Appl. No. 10/669,669

Response to 8/16/05 Office Action

Amendment to the Drawings:

Fig. 20

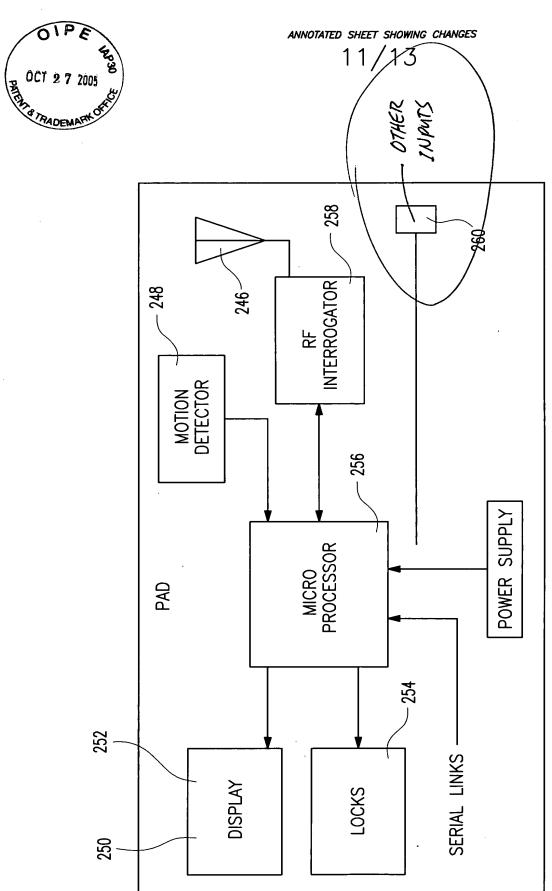
The Examiner has objected to Fig. 20 of the drawings as not complying

with 37 C.F.R. §1.84(o), requiring legends on drawings. It is proposed to amend

Fig. 20 to add a descriptive label "OTHER INPUTS" inside box 260, as indicated

in red, to obviate the objection. Acceptance of the proposed amendment to Fig.

20 is respectfully requested. A formal drawing incorporating the correction is
